RICE LIBRARY BUILDING COMMITTEE

Rice Public Library Monthly Report

Prime Contract Potential Change Order #009 : Historic Shelving Relocation

Prime Contract Potential Change Order #014 : ASI #2 Community Room Ceiling Changes

RFI #1 DETAIL

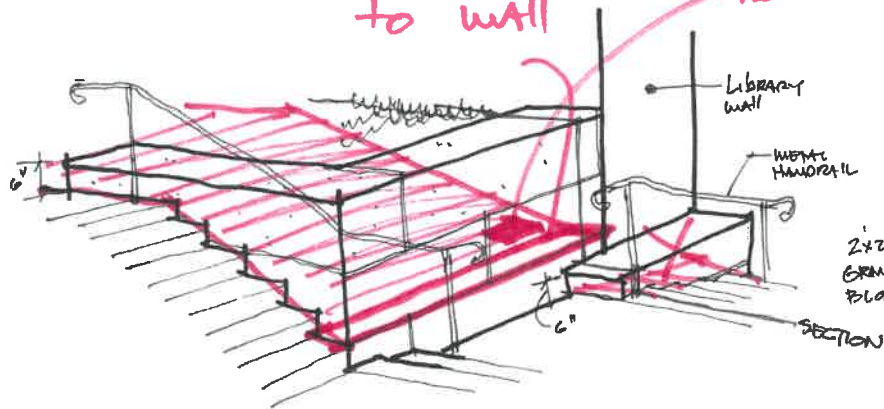
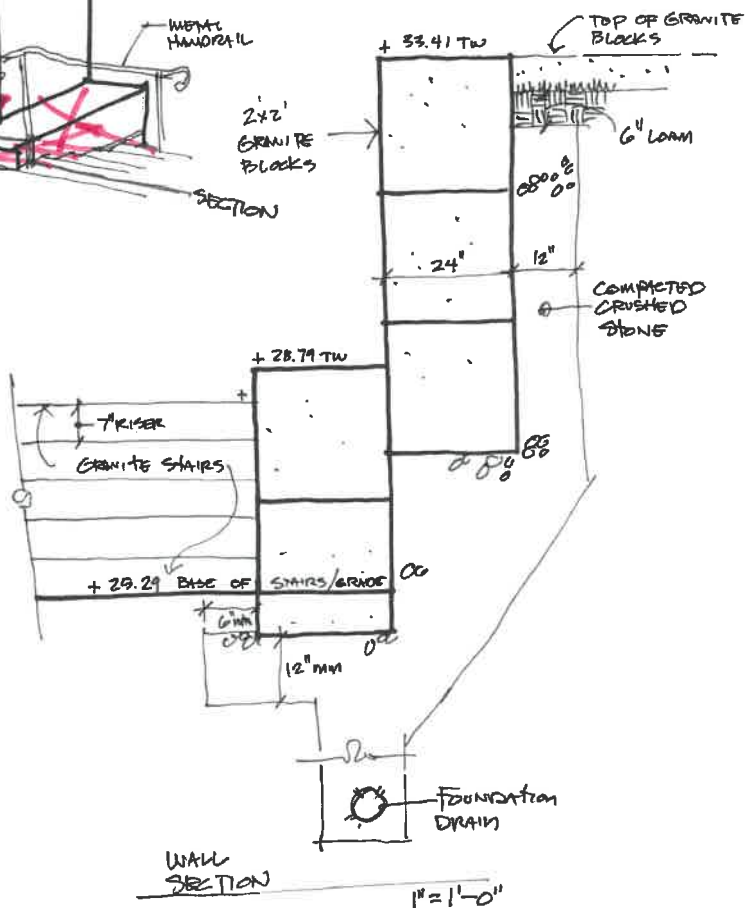
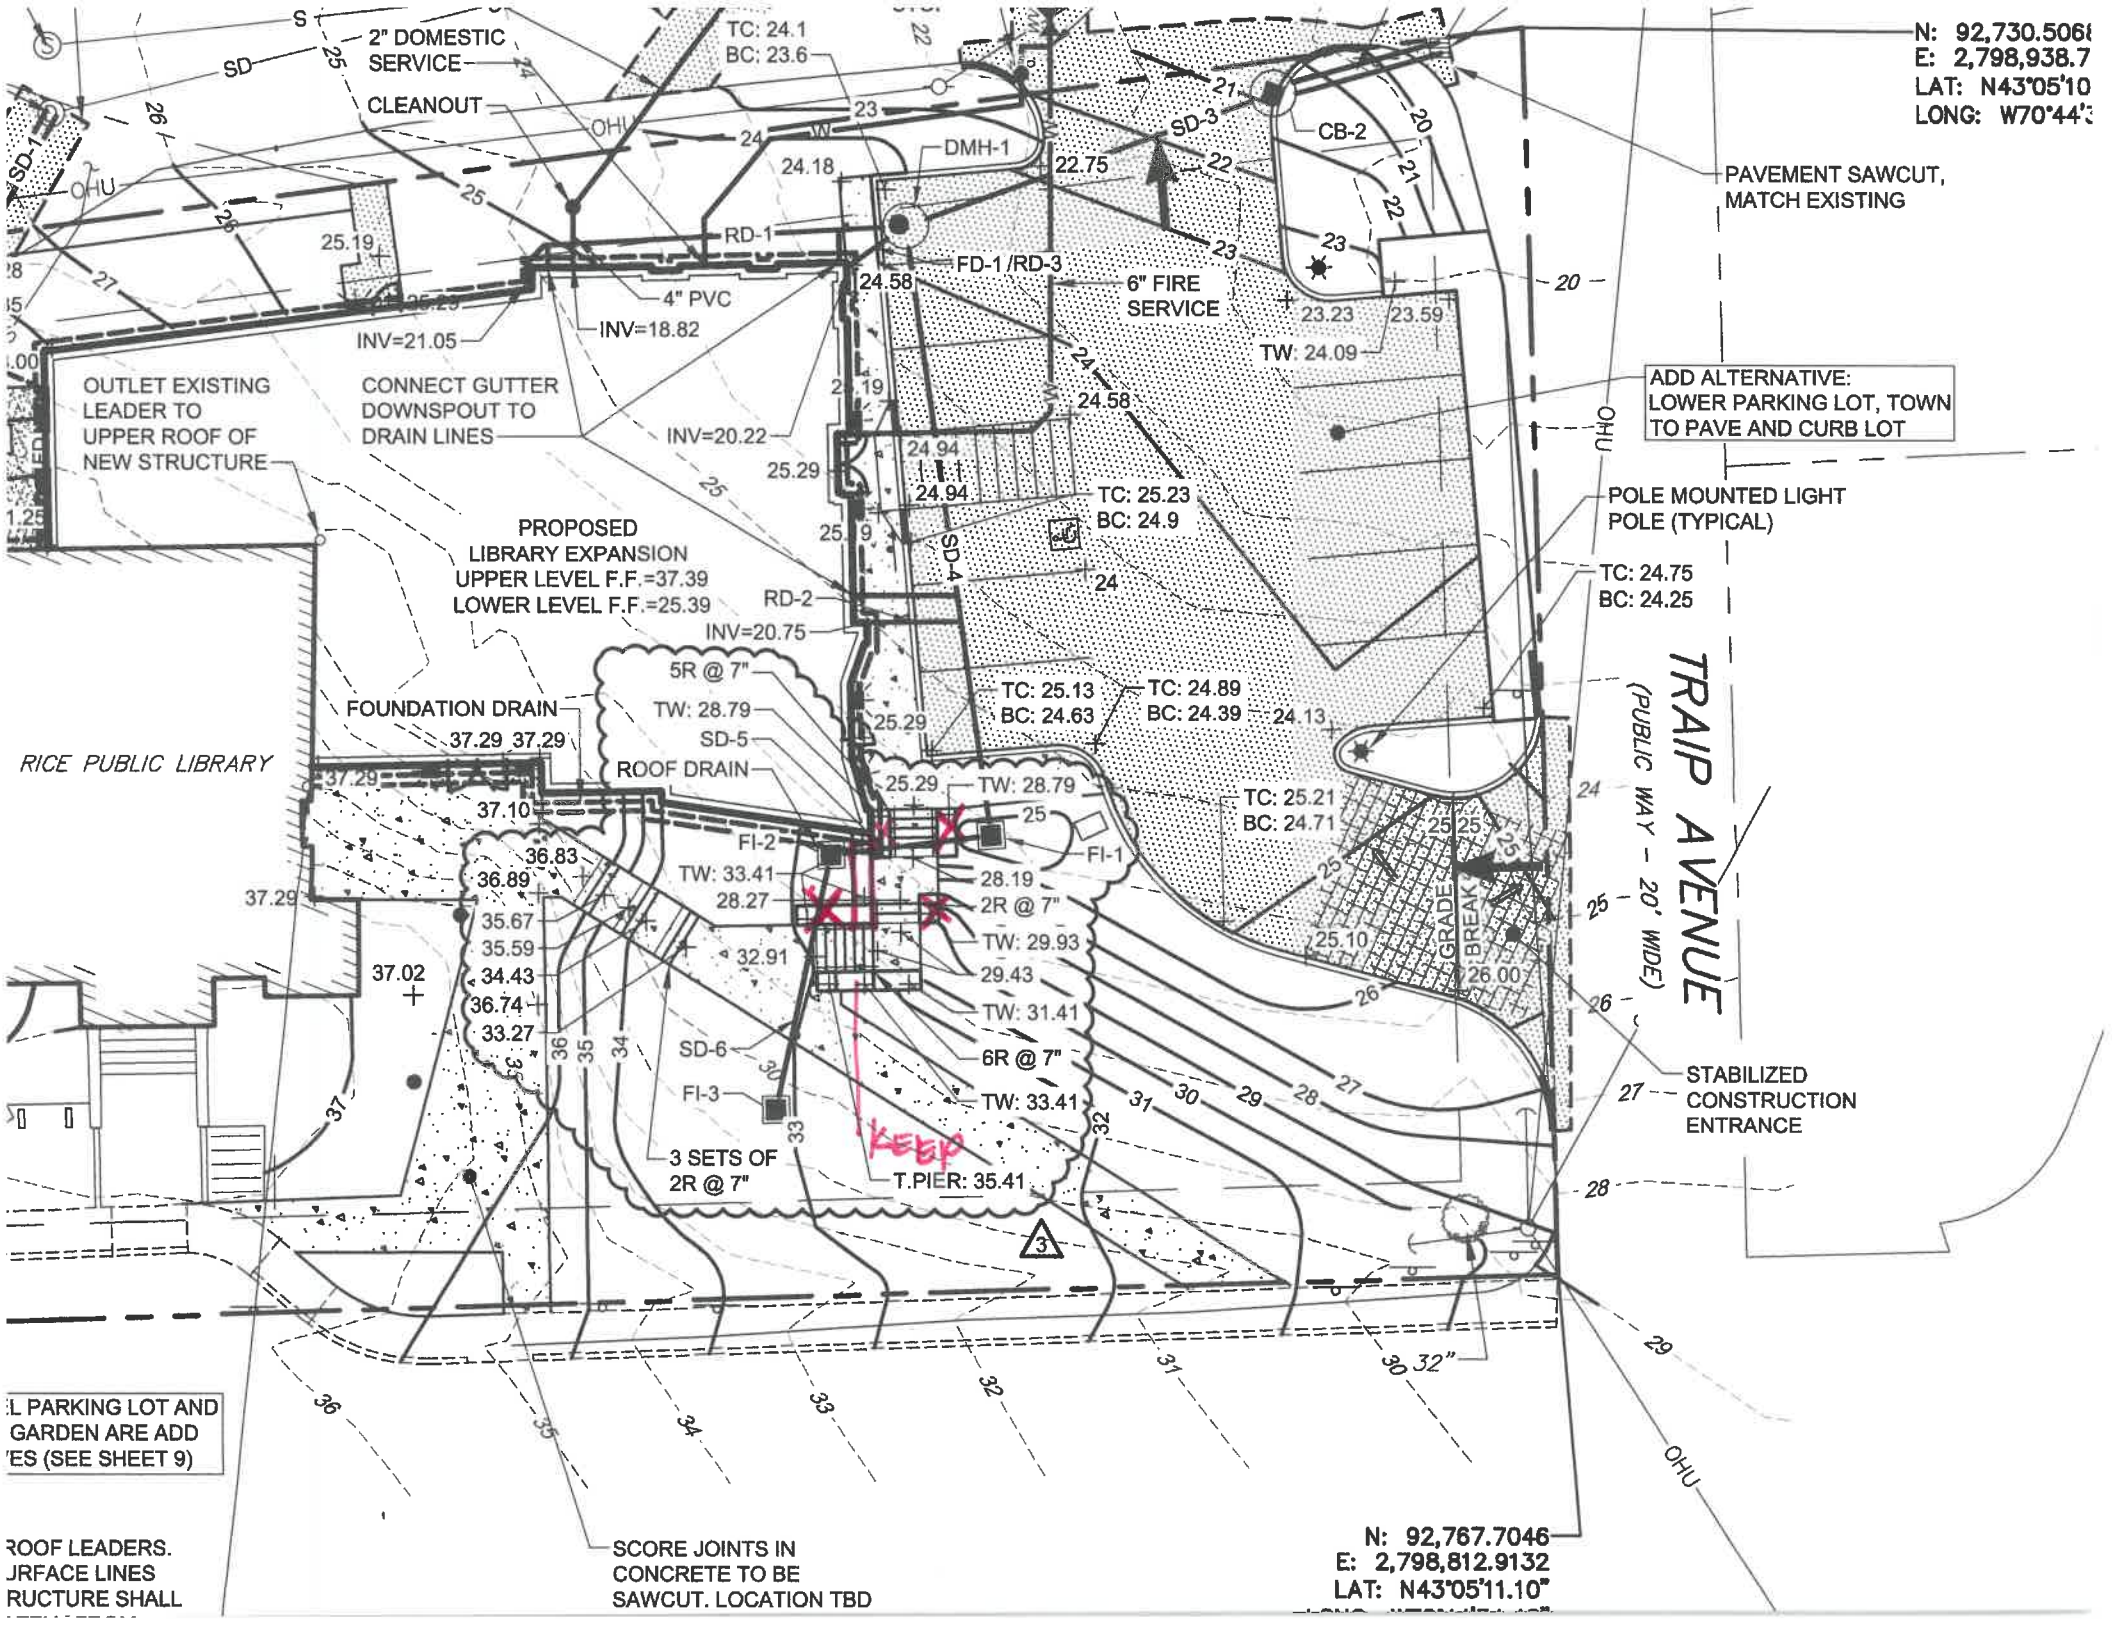
The following is a lump sum PCO to furnish and install the new granite stair case and granite wall with railings and the new concrete sidewalk per the revised alternate shown on the Civil plans and the revised sketch by Sebago dated 3/10/2021(See attached) The scope includes the following:

1. Excavation and prep
2. Wire Mesh
3. Concrete Flatwork
4. New Railings
5. Granite stairs and cheek walls
6. Painting of the rails
7. Concrete Materials
8. Supervision and Project Management. (If this wall can be built with in the contract time frame we can eliminate the Supervision.

ASI-02 RICE PUBLIC LIBRARY
COMMUNITY RM CEILING

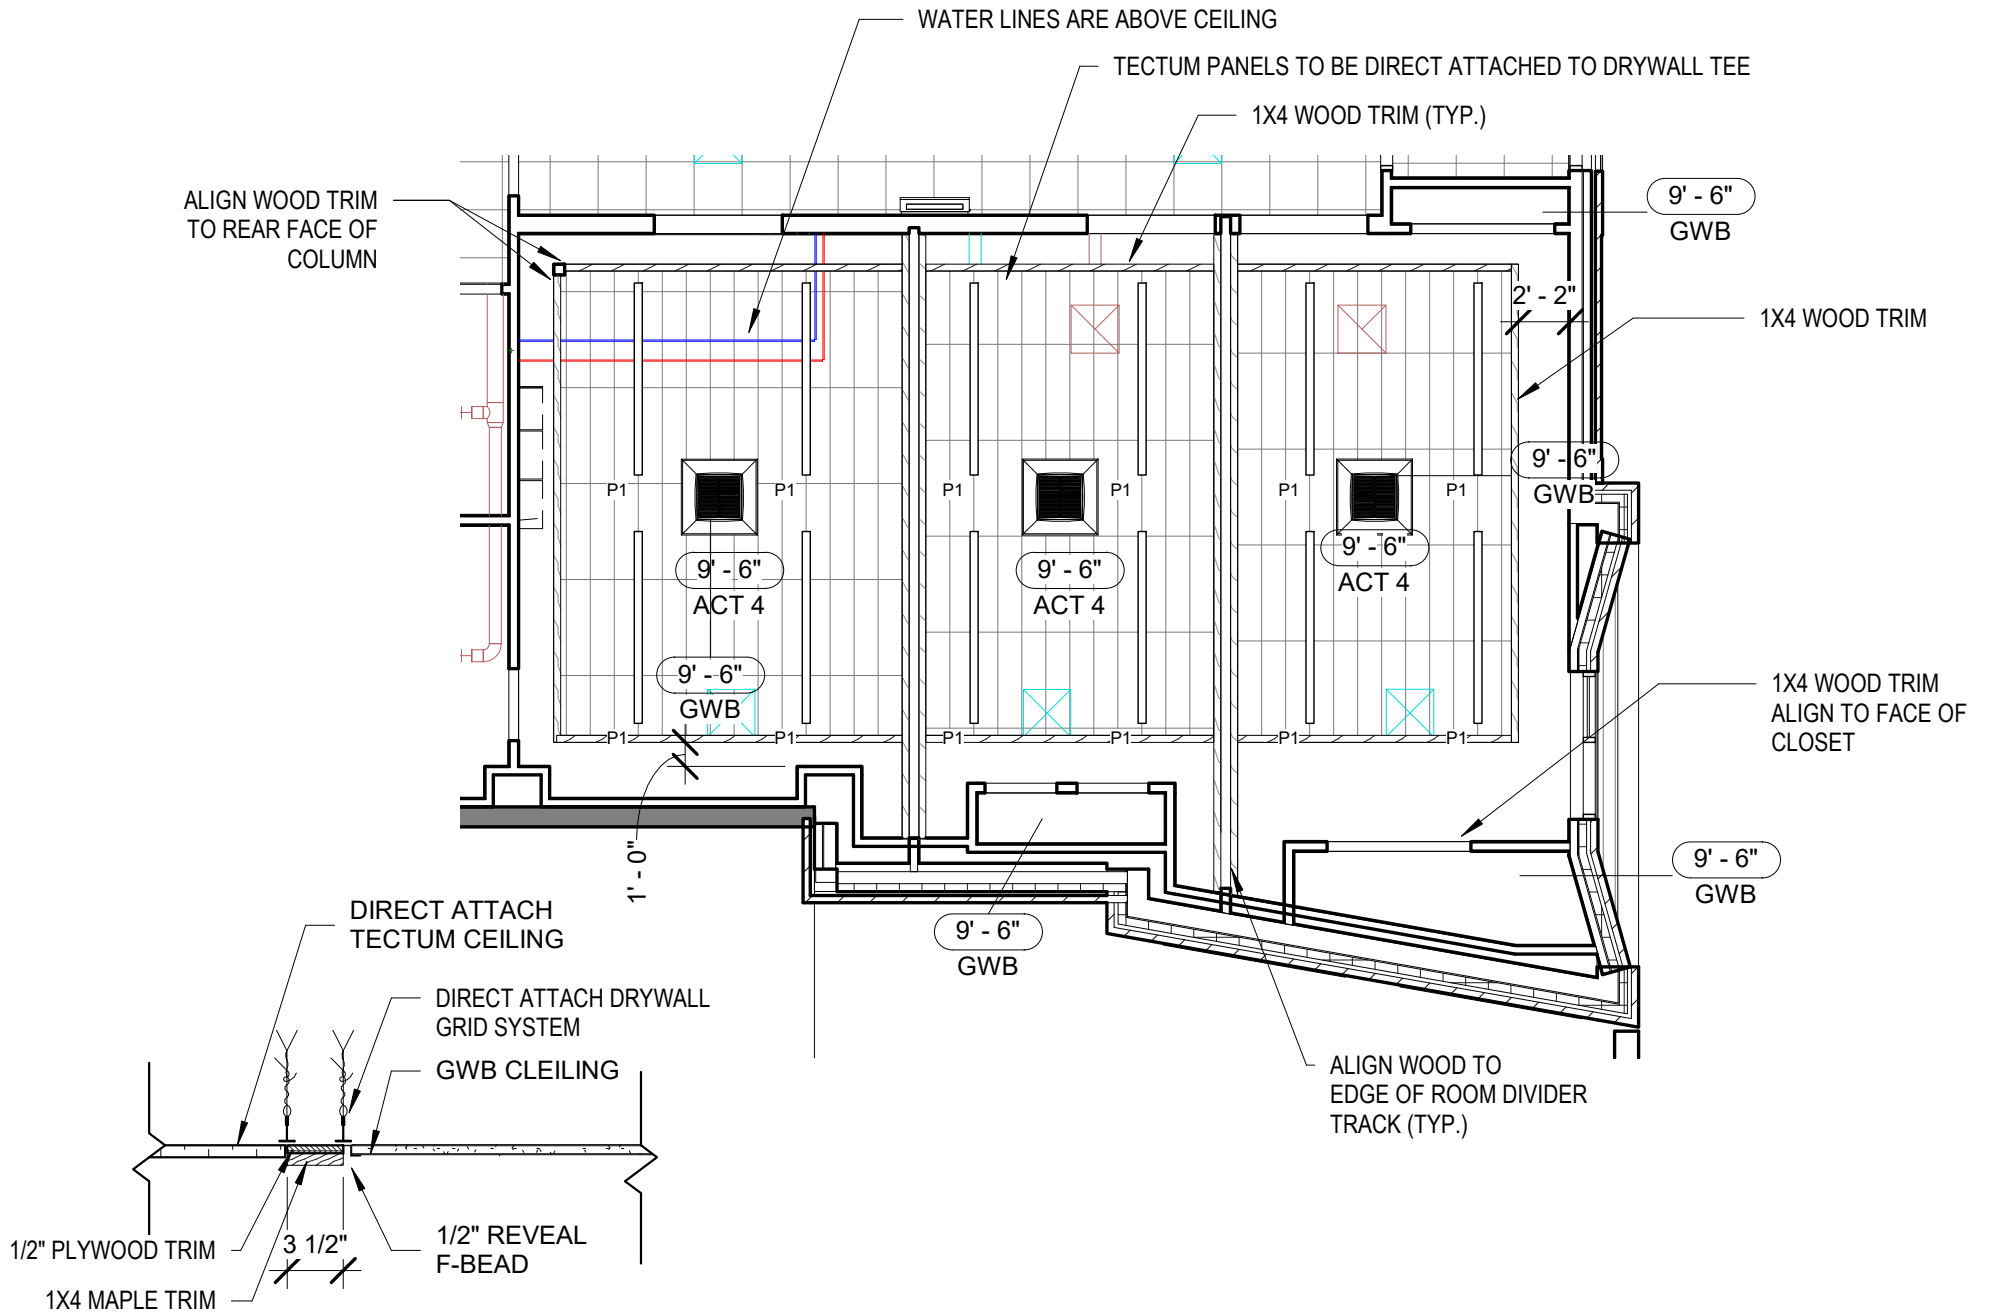
The following is a lump sum PCO for the added and deleted scope on the community room ceilings that was called out in ASI #2. The scope includes:

1. Deleted tectum ceiling area
2. Added hard ceiling 5/10/2021
3. Added plywood and maple trim

As per ASI-2
Reduce tectum panels in rooms 003, 004 and 005
960 square feet reduces down to 780 square feet
